On behalf of the Center for Biological Diversity, the Grand Canyon Trust, the Grand Canyon Wildlands Council and the Sierra Club's Grand Canyon Chapter, please find attached comments on the Draft Environmental Impact Statement for the Northern Arizona Proposed Mineral Withdrawal.

4 May 2011

**RE: COMMENTS ON THE NORTHERN ARIZONA PROPOSED MINERAL
WITHDRAWAL DRAFT ENVIRONMENTAL IMPACT STATEMENT**

Figure 1. White-faced ibis (*Plegadis chihi*) perched near the Pinenut uranium mine tailing pond in April, 2011.

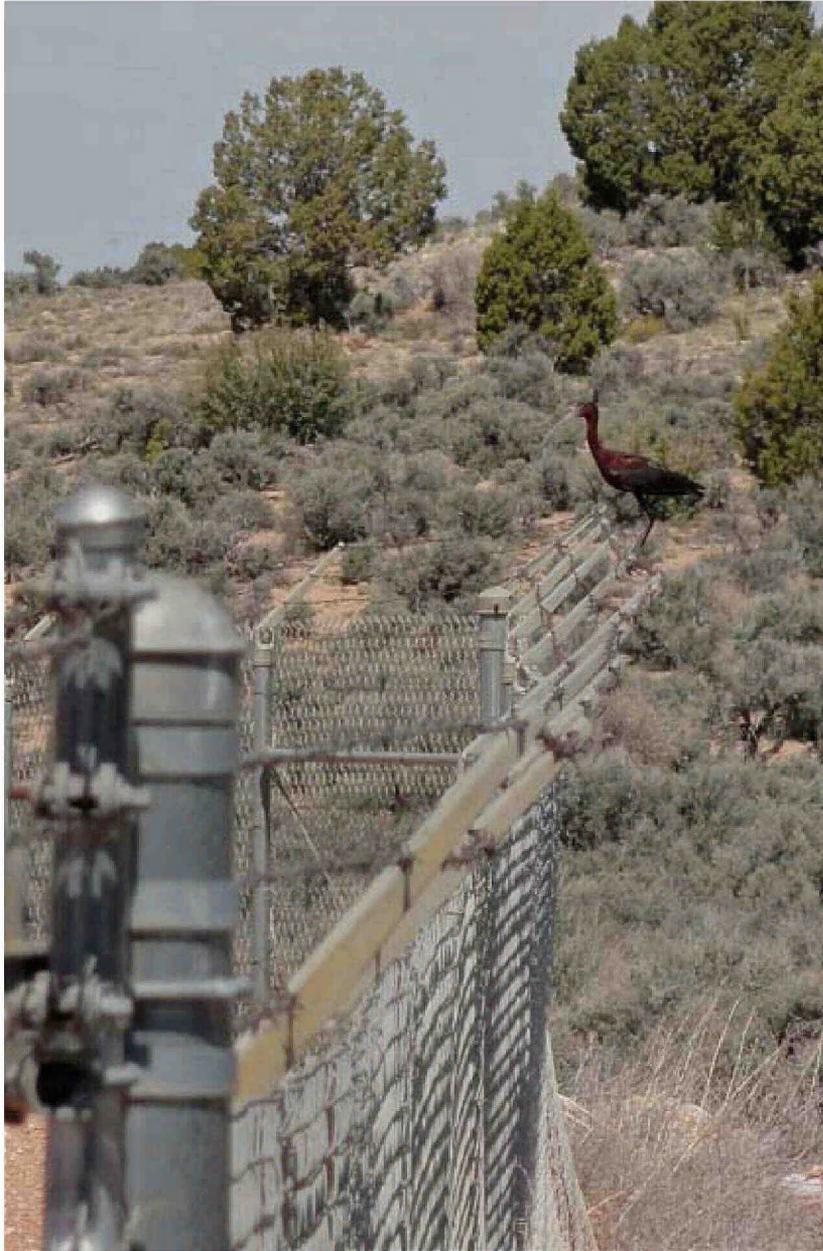
Nor does the DEIS sufficiently consider the potential impacts of uranium mines on migrating birds. BLM does not require uranium mine tailing ponds to be covered. Migrating birds, especially water birds, can therefore be attracted to mine tailing ponds for feeding, wading, drinking, bathing and resting during migration. Because mine water can be polluted with mining waste, exposure to mine tailing pond water could poison or kill migrating birds. Because mine ponds contain no fish or invertebrates, migrating water birds that are attracted to and attempt to forage in mine tailing ponds will expend energy attempting to gain energy, thereby depleting rather than restoring critical fat reserves necessary for migration. In these ways, uranium mining tailings ponds can serve as habitat traps for migrating birds. In April of 2011 Taylor McKinnon of the Center for Biological Diversity documented a White-faced ibis (*Plegadis chihi*) at the Pinenut mine tailing pond. It was perched on the barbed-wire fence adjacent to the pond and was observed perched at and flying over the pond. (Figure 1)

Figure 2. (Left) A map compiled by Arizona Game and Fish Department shows deer migration between Grand Canyon and the San Francisco Peaks, (Right) A map of dispersing mountain lion P1 reveals a nearly identical route used by other large mammals (NPS data).

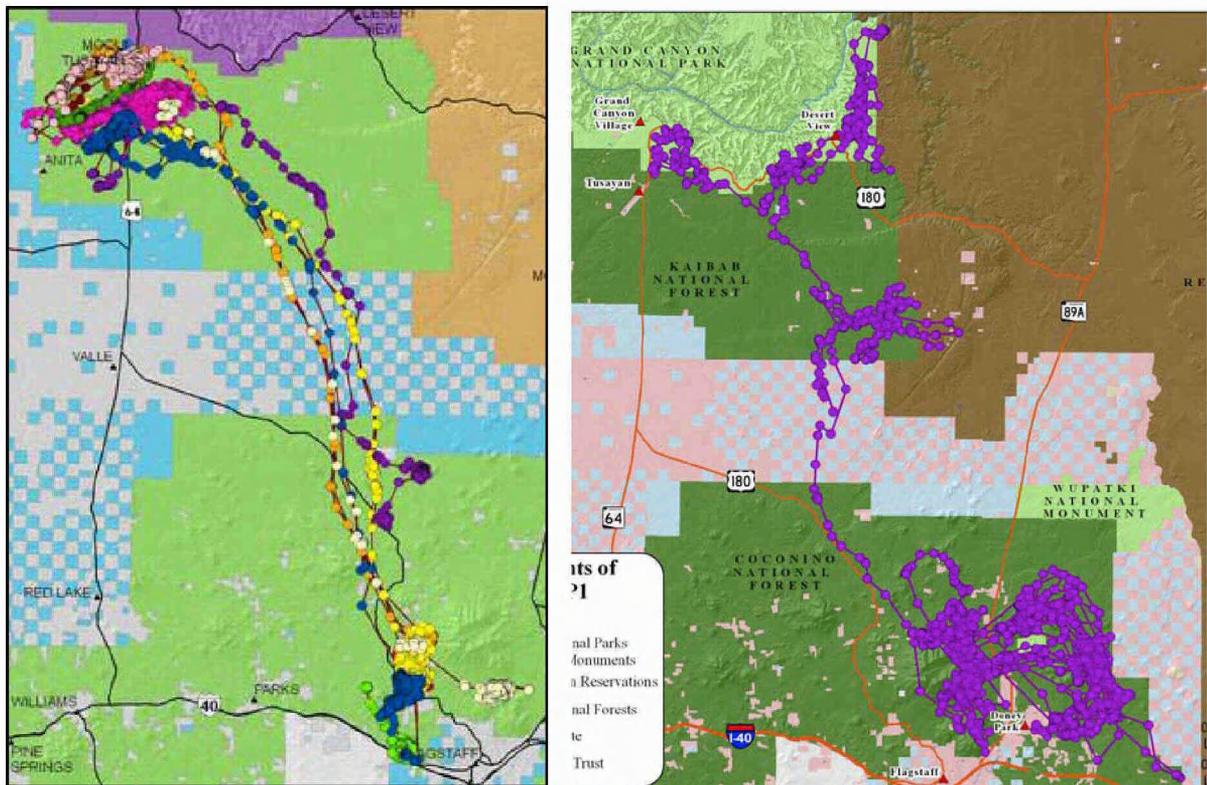
Fig. 3.7-1 in the DEIS ignores some critical wildlife linkages, and may therefore underestimate the impacts of mining and hauling on large mammals. Maps of radio-collared deer prepared by the Arizona Game and Fish Department (AGFD), and a dispersing mountain lion tracked by the National Park Service (NPS), reveal nearly identical travel routes for these large mammals between the Grand Canyon and the San Francisco Peaks (Fig. 1, this document). Fig 3.7-1 should be amended to show this corridor, which covers a large portion of the south segregation area. Mining and trucking activities that bisect a wildlife corridor could disproportionately impact animal populations. Mule deer and elk stay

Impacts to deer, elk, antelope, and turkey will negatively impact wildlife populations and recreation (hunting, wildlife watching, photography).
